SAFETY EVALUATION BY THE OFFICE OF NEW REACTORS  
TOPICAL REPORT ANP-10286P, REVISION 0  
"U.S. EPR ROD EJECTION ACCIDENT METHODOLOGY TOPICAL REPORT"  
AREVA NP, INC.  
DOCKET NO. 52-020

Figure 2 – Details of Analysis Methodology (0 - ~ 5 sec.)

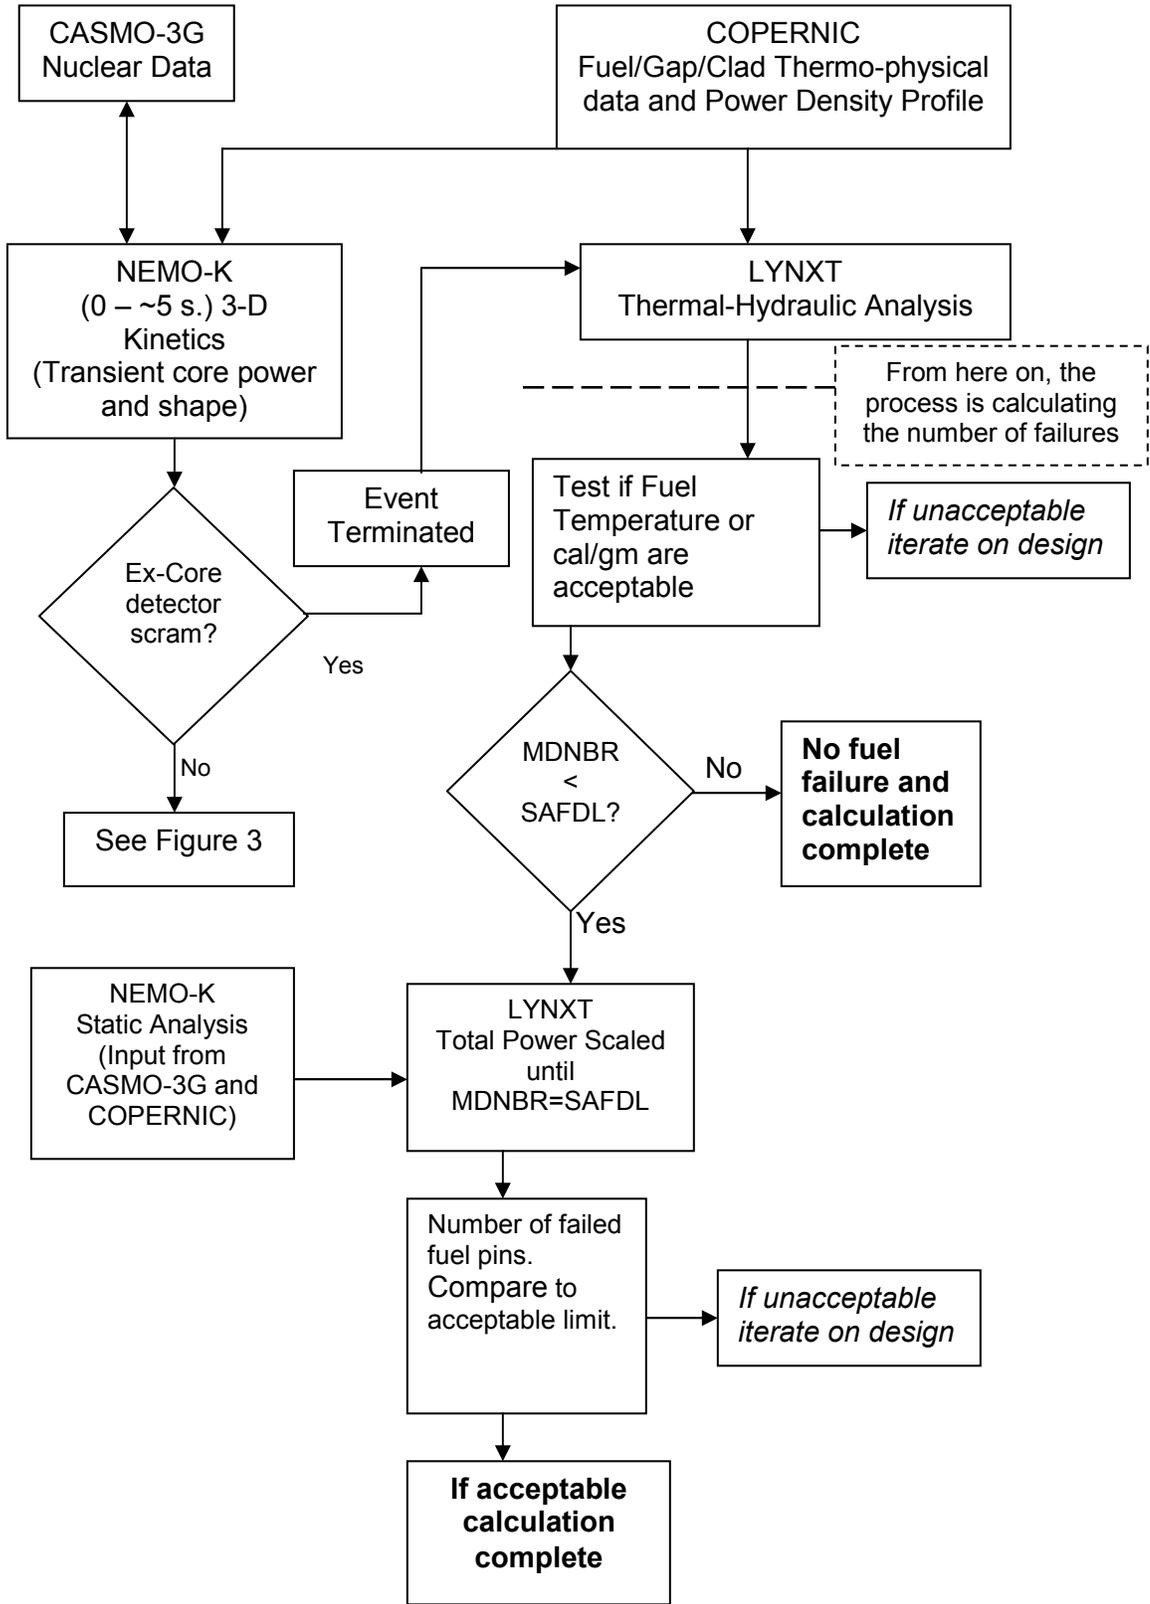
AREVA noted on Figure 2 that the box with “Ex-core detecto” is missing some text.

NRC staff corrected the figure.

Figure 3 – Details of Analysis Methodology (greater than approximately 5 sec.)

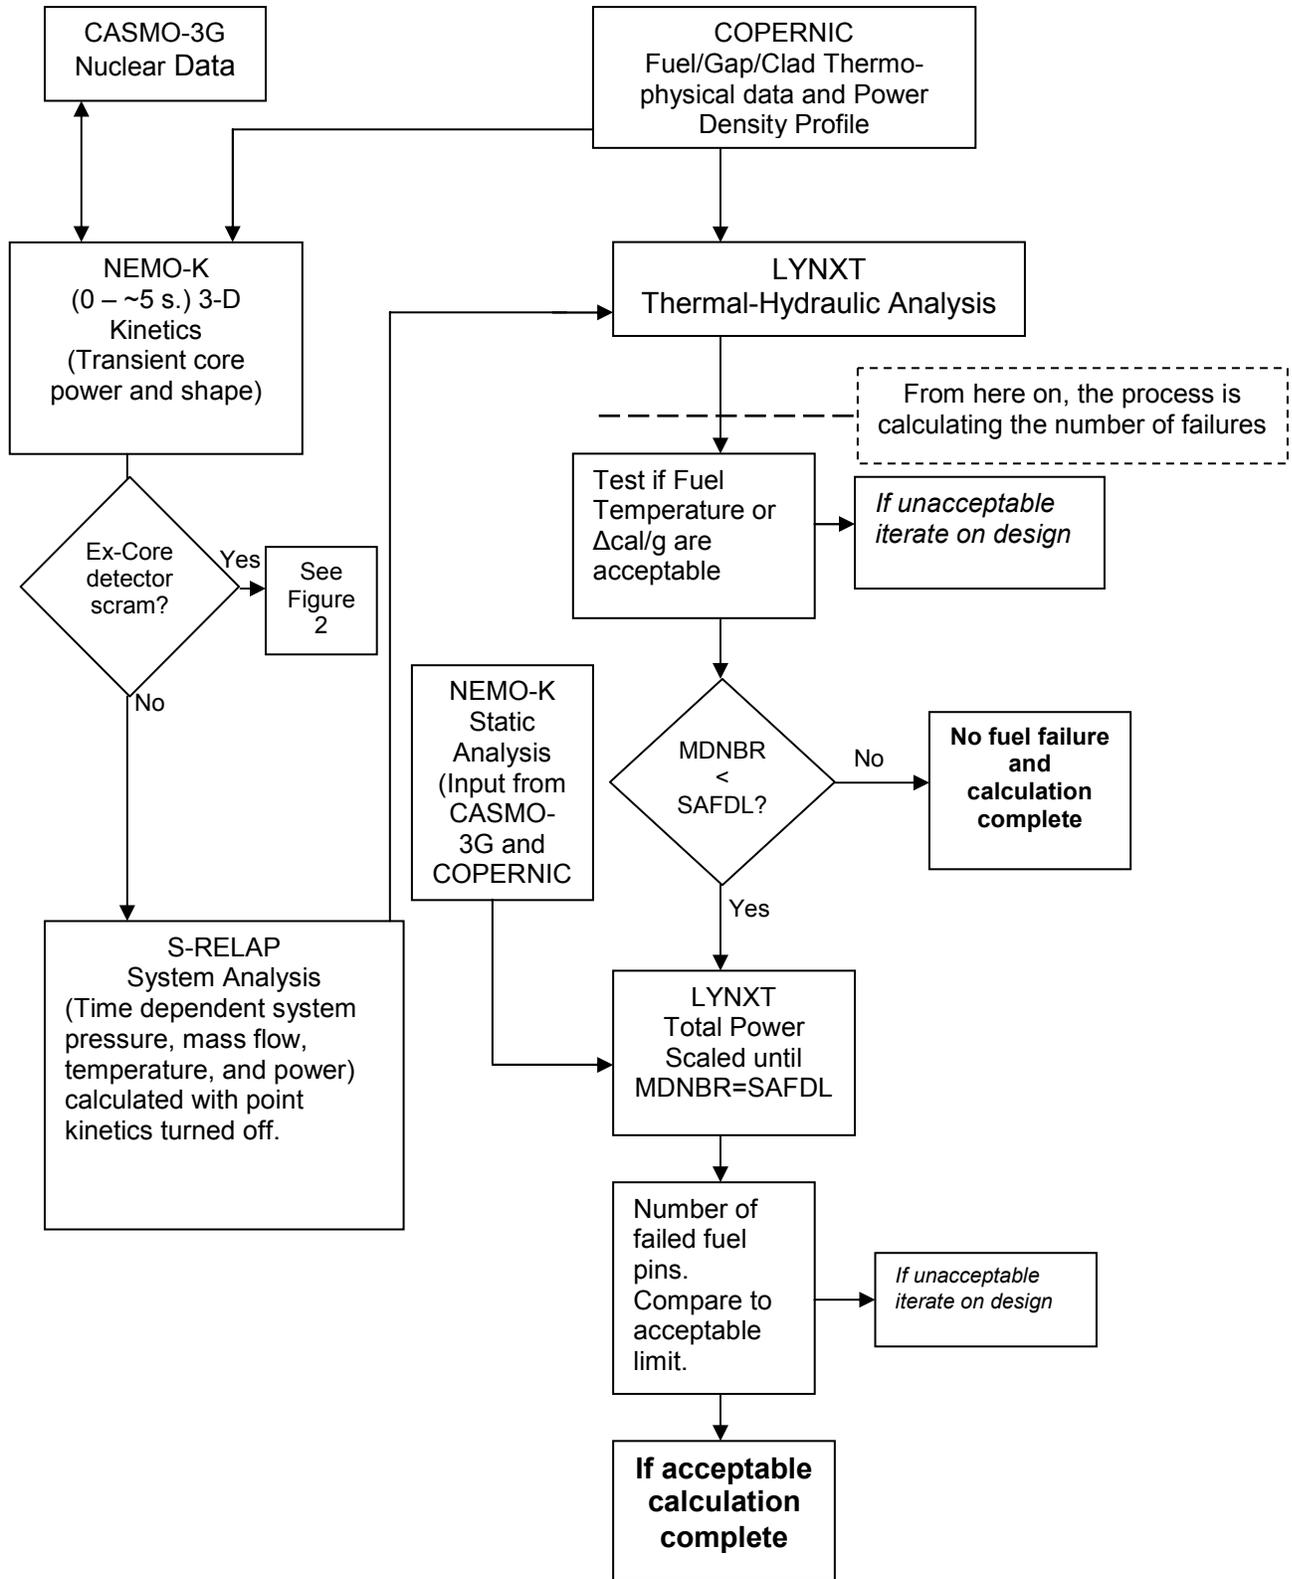
AREVA noted on Figure 3 that S-REALP should be S-RELAP5 in boxes and that the words “No scram” in the NEMO-K box were incorrect.

NRC staff corrected the figure.
